FirstEnergy Nuclear Operating Company

July 11, 2008
L-08-209

Beaver Valley Power Station, Unit Nos. 1 and 2

Reply to Request for Additional Information for the Review of the Beaver Valley Power Station, Units 1 and 2, License Renewal Application (TAC Nos. MD6593 and MD6594), and License Renewal Application Amendment No. 15

BVPS Unit 1 Heatup Projection

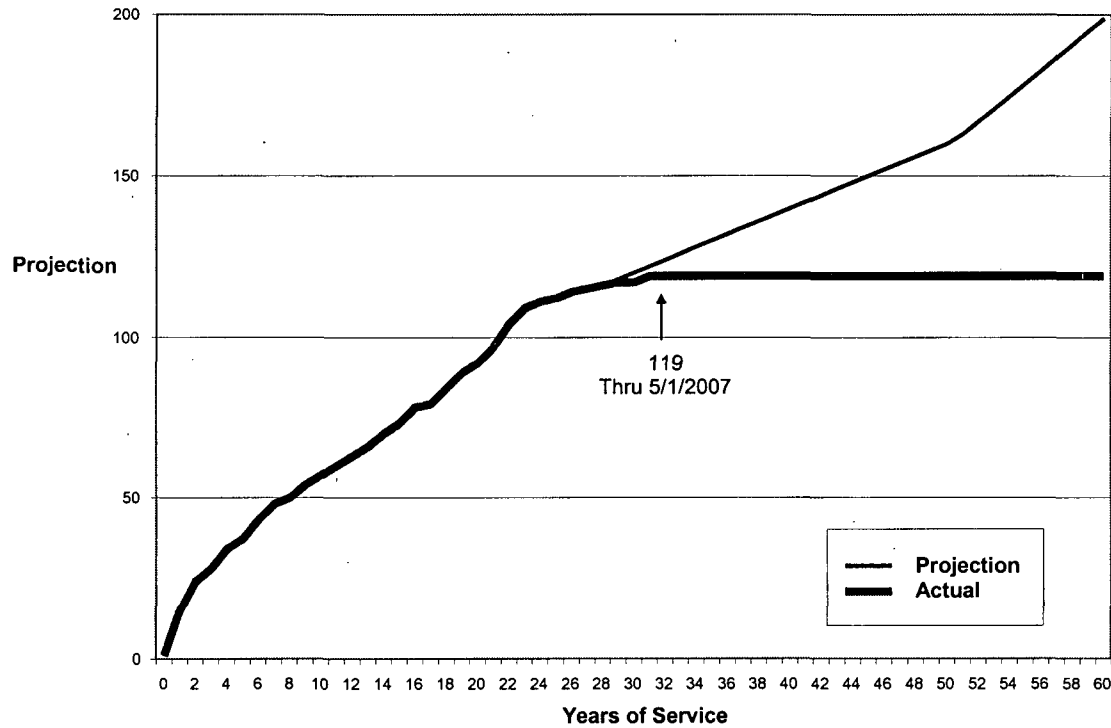
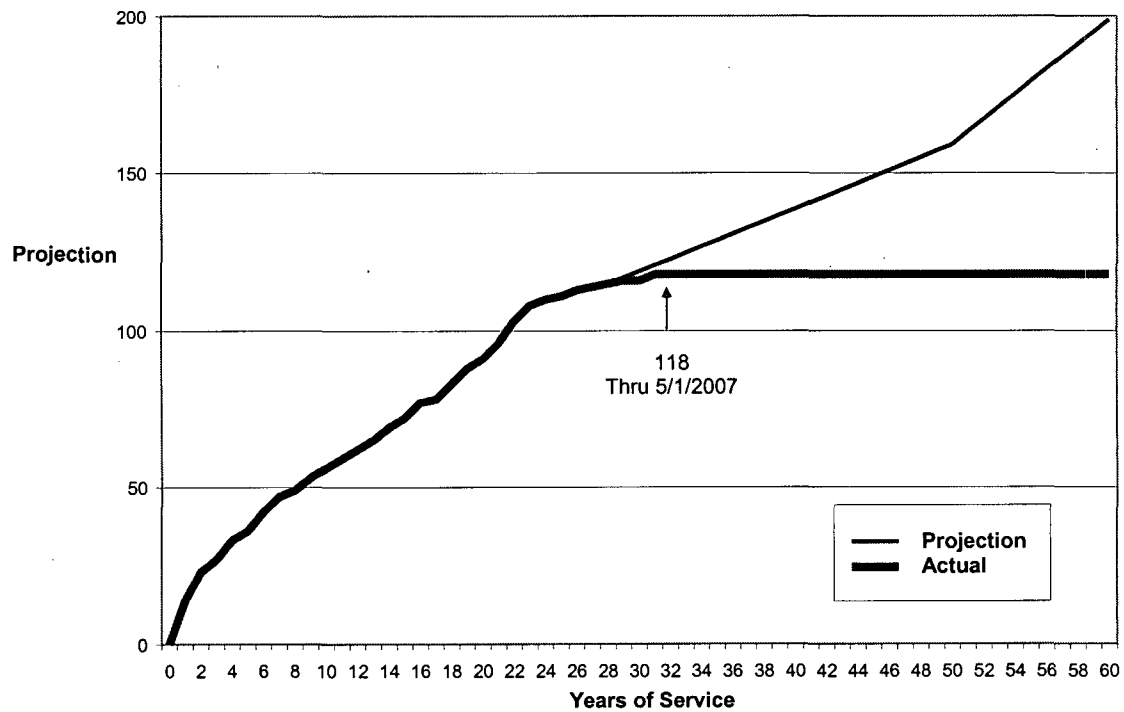
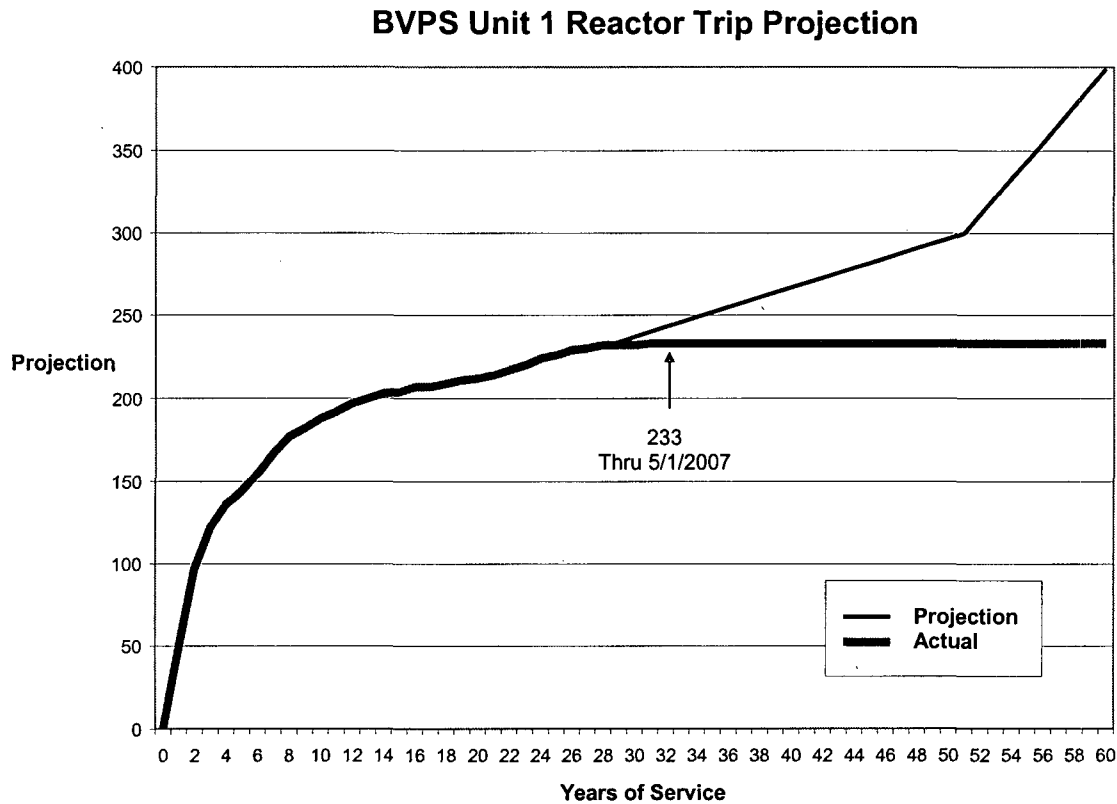
LRA Section 4.3.4 states that histograms were developed based on the last ten years in order to perform an extrapolation for the number of transients that will be accumulated in 60 years of operation for plant heatup and cooldown, and pressurizer cooldown. Please provide the histograms that were developed and describe the method used to extrapolate these cycles to 60 years of operation.

Histograms were developed using accrued cycles through October 15, 2003, for the Unit 1 plant heatup, plant cooldown, and reactor trip transients. For these transients, the 60-year projected operational cycles were based on recent operating experience (i.e., the last ten years). In addition, the Unit 1 reactor trip transient was biased with additional reactor trips as Unit 1 approaches end-of-life (60-years). For all other transients, the accrued cycles were linearly extrapolated to obtain the projected 60-year projected operational cycles. Since the Unit 1 plant heatup, cooldown, and reactor trip transients are expected to approach or exceed the number of design cycles during the sixty year operating life of the unit, the Metal Fatigue of Reactor Coolant Pressure Boundary Program requires monitoring of these transients and provides for preventive and/or corrective action prior to exceeding the fatigue design limit.

As part of an annual review of the monitored transients, the histograms for the Unit 1 plant heatup, plant cooldown, and reactor trip transients were updated with accrued cycles through May 1, 2007. In addition, all three of the subject transients were biased with additional cycles as Unit 1 approaches end-of-life (60-years). These histograms are provided as follows:

Figure B-1: ASN 7 Hoop Stress Comparison (ANSYS vs. WESTEMS) for Shock Transient Loading

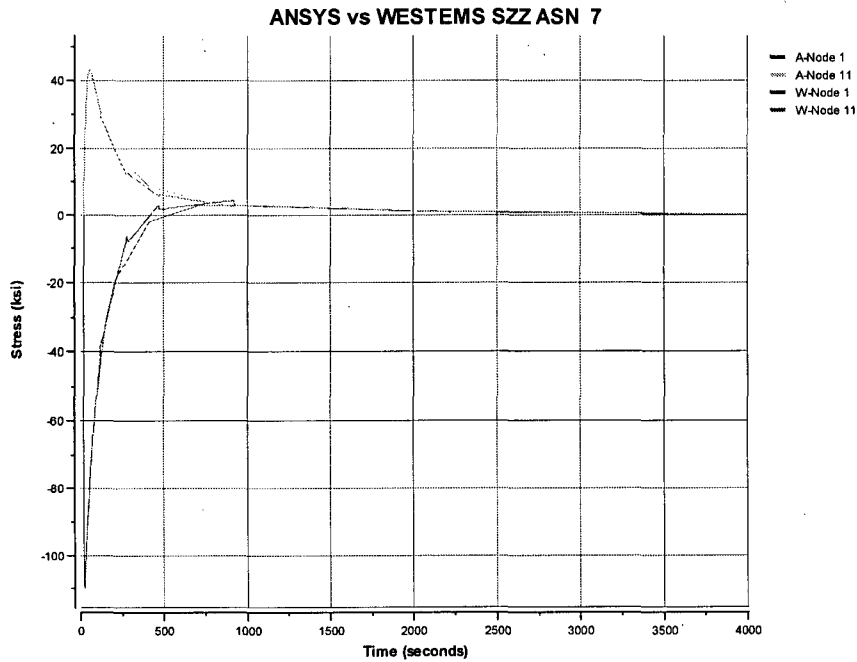
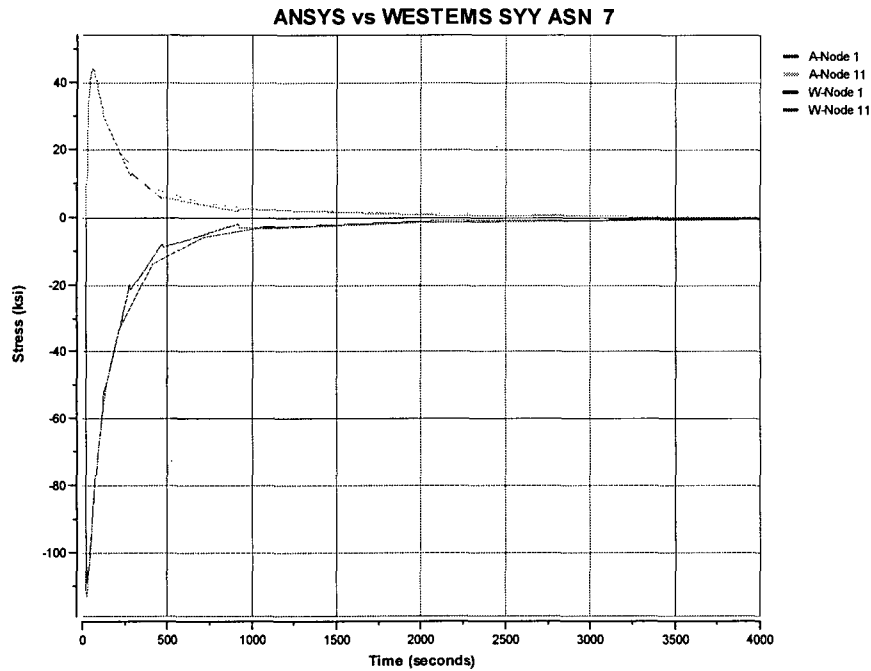
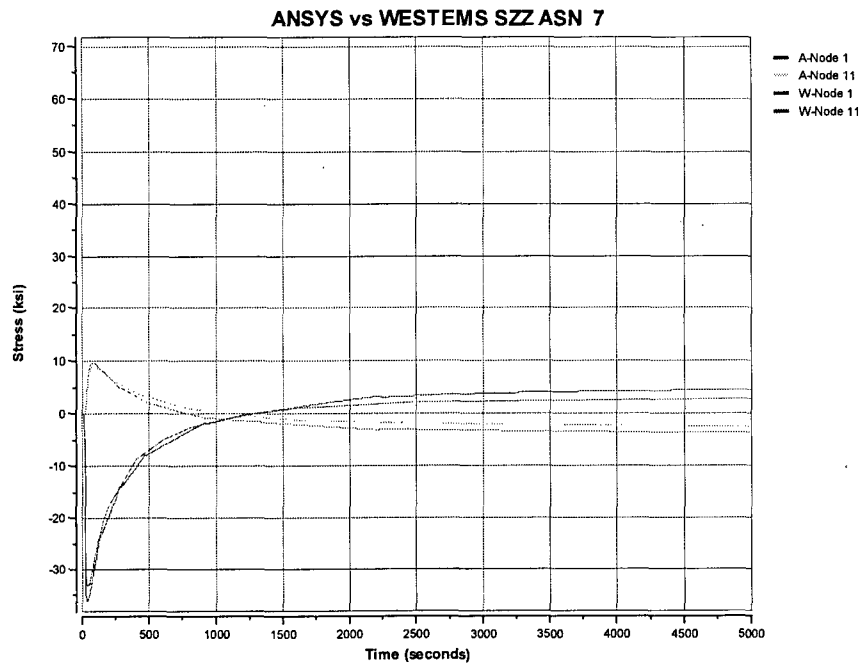
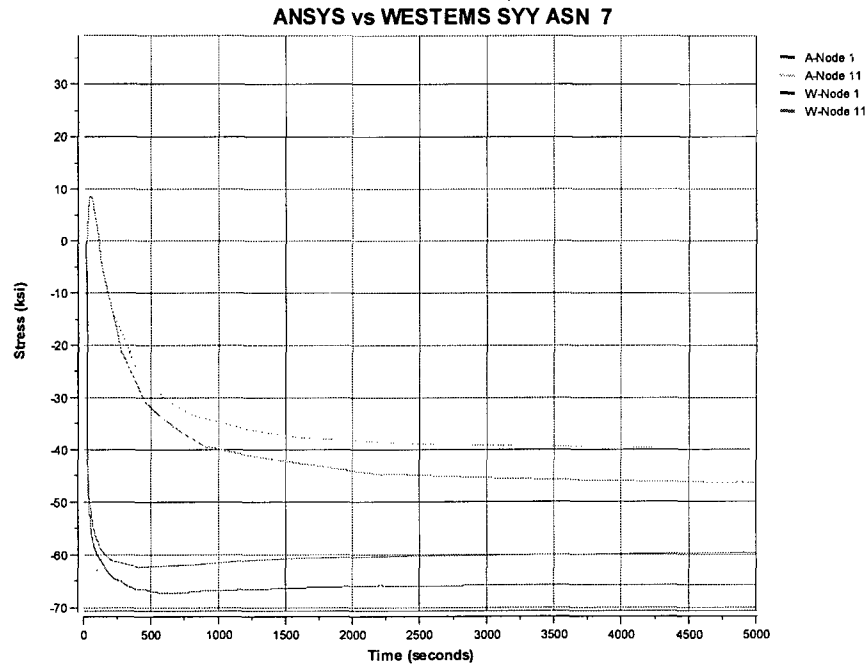
- Please explain the purpose of the WESTEMS in the management of components subject to metal fatigue including NUREG/CR-6260 components for the period of extended operation.**
- Please provide the benchmarking results for the WESTEMS software using relevant transient data, and proper 3-D model. Please justify the use of WESTEMS to update the cumulative usage factors (CUF) calculation by using the monitored or projected transient data (cycles) and discuss the conservatism in the calculation on a plant specific basis.**

The shapes of the curves of the stresses from the WESTEMS™ analysis are visually compared with those from the ANSYS full finite element analysis. In general, good comparisons are observed for all cases. The stratification case shows slight differences in stress magnitude in the steady state stratification condition, which is expected. This is caused by the inside surface film coefficients changing values between zones, which is accounted for in ANSYS by two-dimensional heat transfer, but is not fully accounted for in the WESTEMS™ benchmark run. The results from WESTEMS™ predict slightly higher stresses at the stratified steady state condition, which therefore leads to conservative answers and is not considered a concern.

Overall, very good benchmarking results have been achieved, which assures good results can be produced through the TFDB created. Since WESTEMS™ results are either close in magnitude or slightly higher than the ANSYS benchmark results, the factor, $f_1=1.00$, is applied. Since the stress unit in the ANSYS FEA results is psi, whereas the stress unit to be used for WESTEMS™ calculations is ksi, a factor, $f_2=0.001$, is required. Combining the two factors, the scaling factor for the thermal load to be used for WESTEMS™ analyses is $f_T = f_1 * f_2 = 0.001$, which is to be registered to the “TFDB_Factor” box in the WESTEMS™ ASN Analysis Models.
